DESIGN	CHECK	APPROVAL	Model
			Title: MCU
			Document Number / Rev 1
WooYoung Telecom Co., Ltd.			Sheet 3 of 6

DESIGN	CHECK	APPROVAL	Model H750D
			Title AUDIO
			Document Number / Rev 1
WooYoung Telecom Co., Ltd.			Sheet 6 of 6

Title	DVI	
Size A3	Document Number <Doc>	Rev <RevCode>
Date: Saturday, July 05, 2003	Sheet 2 of 6

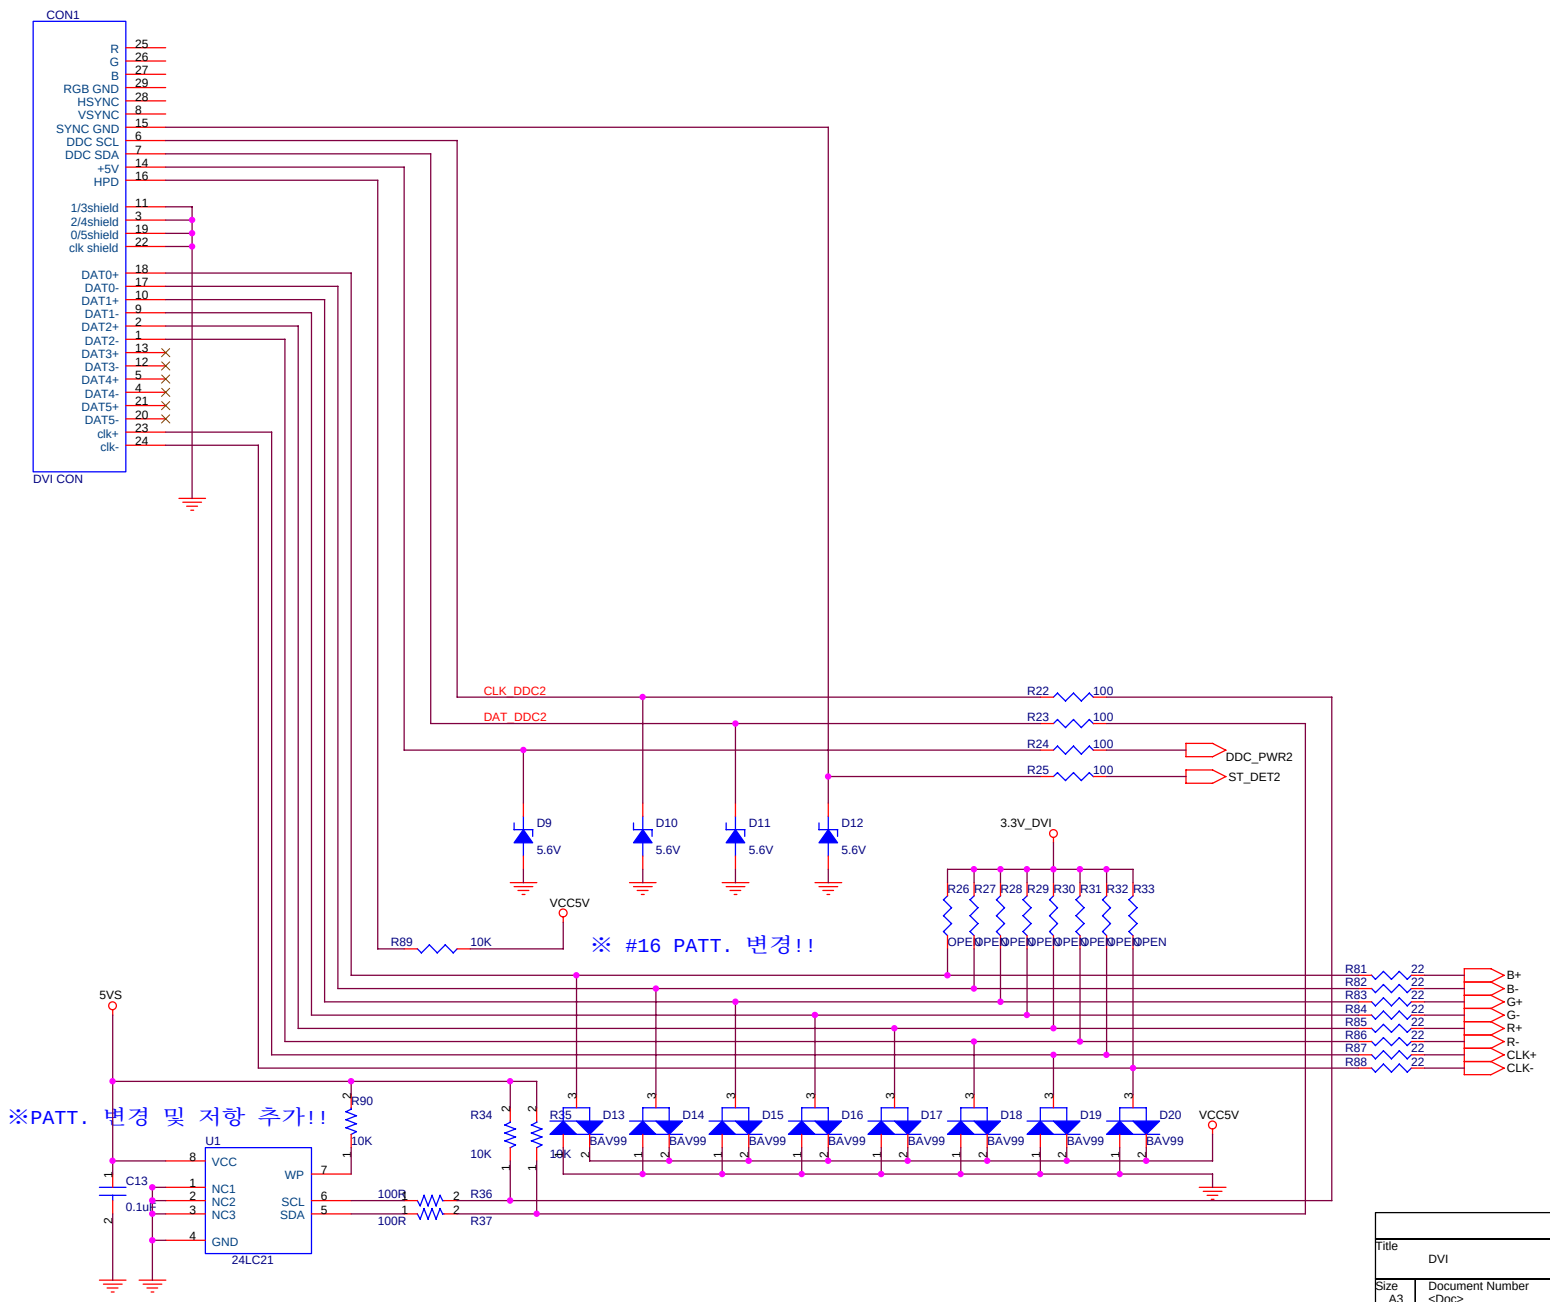
1. ST_DET2의 DVI PIN 변경

1. 24LC21의 VCLK 수정

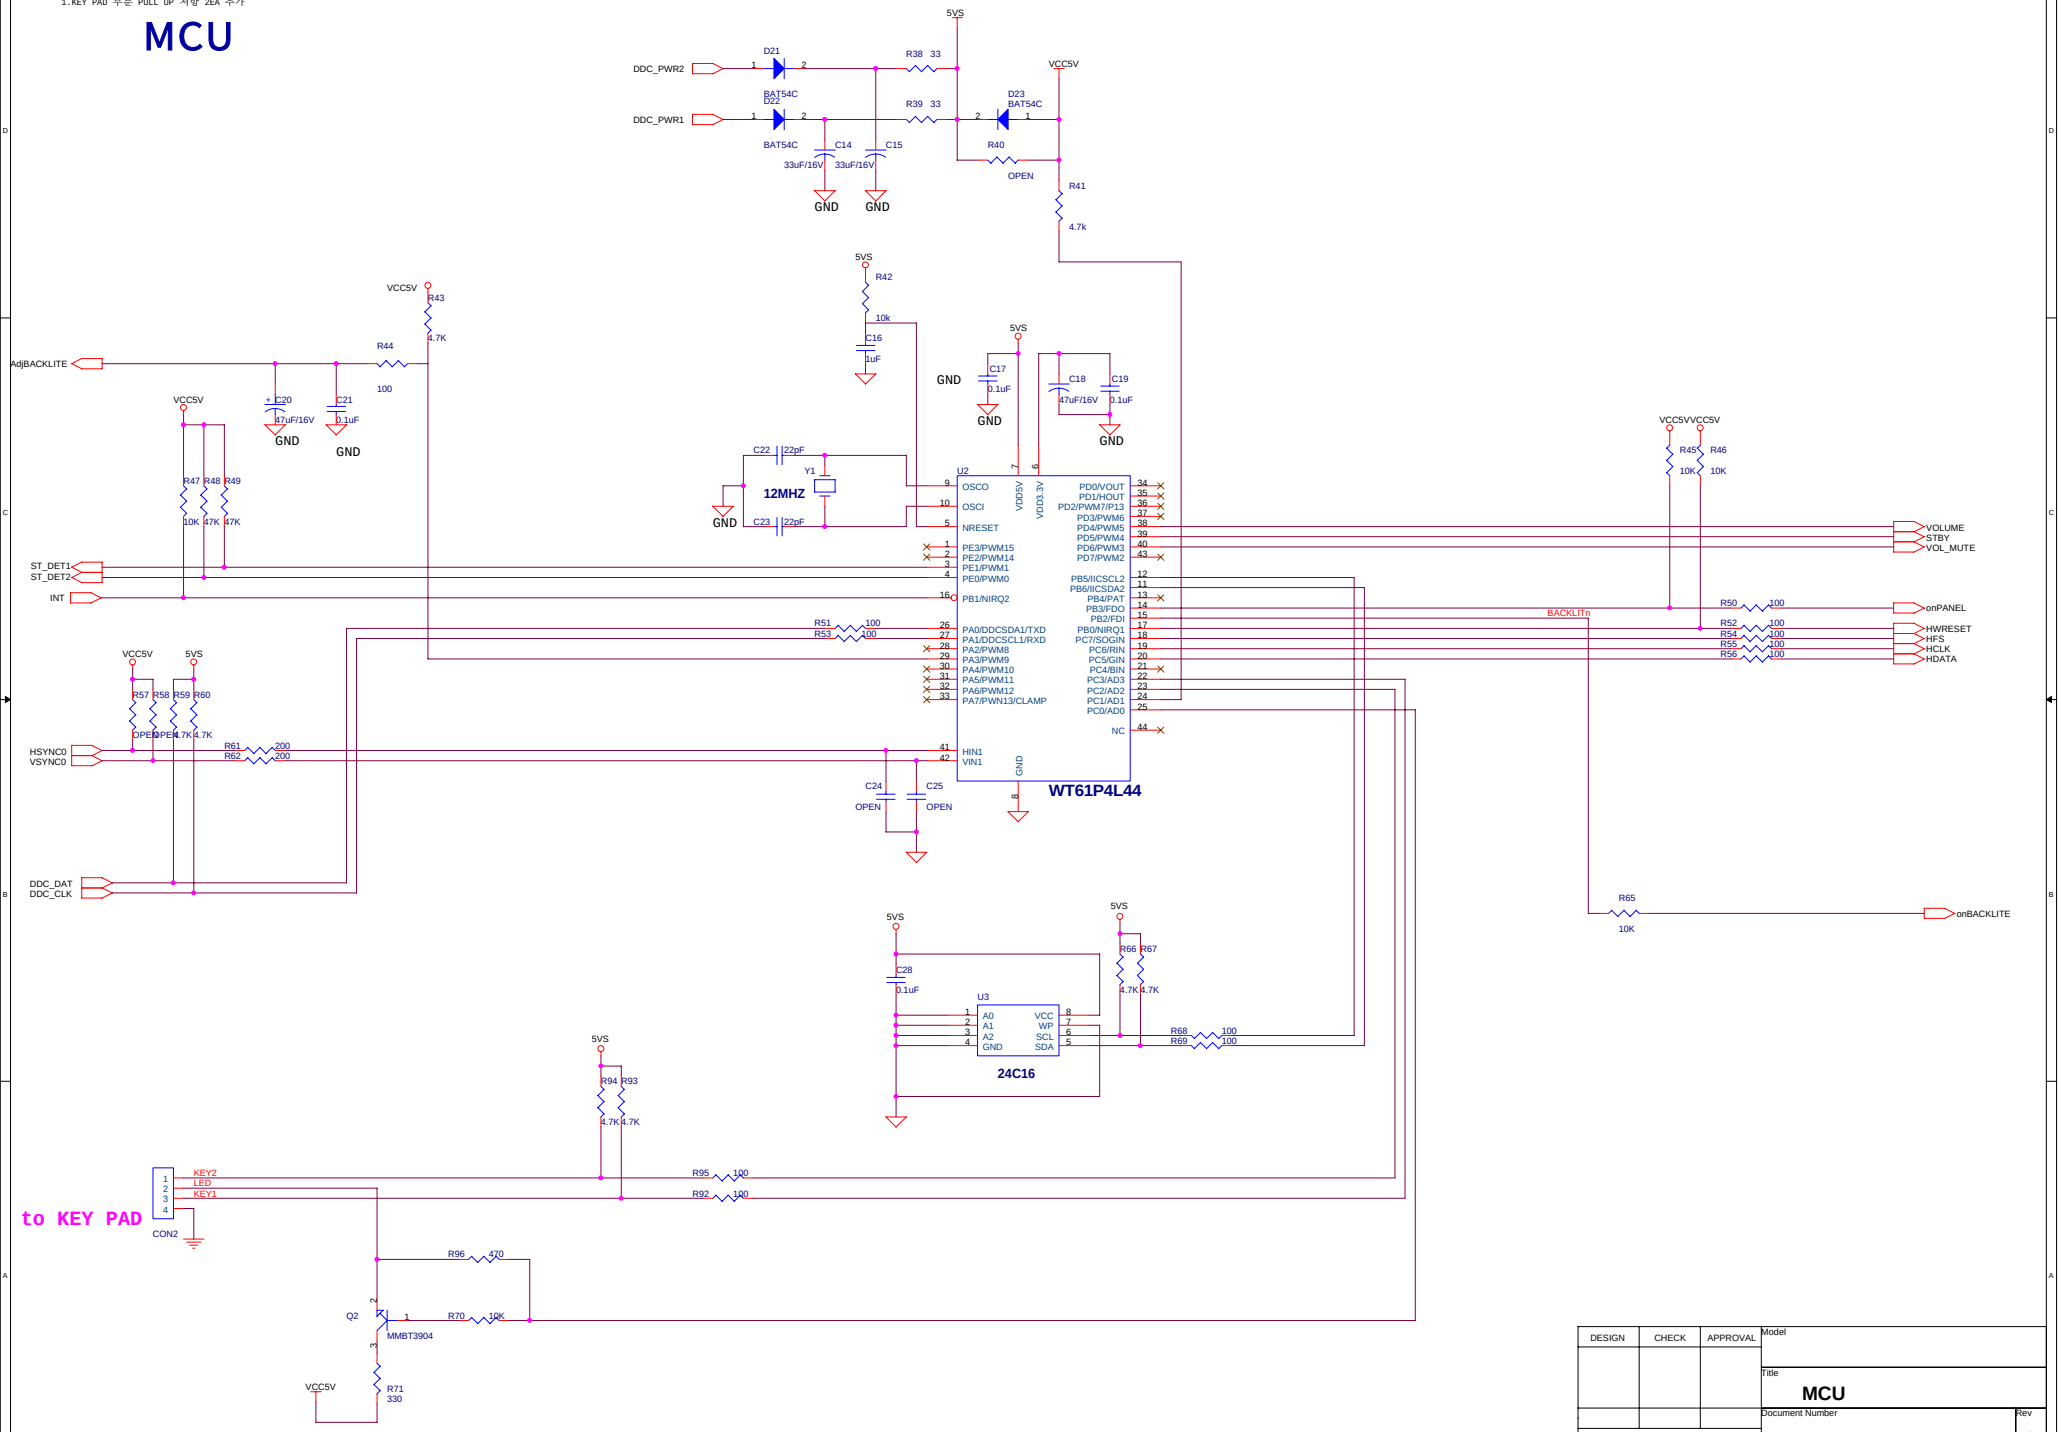
1. R43위치 이동!!

1.KEY PAD 부분 PULL UP 저항 2EA 추가
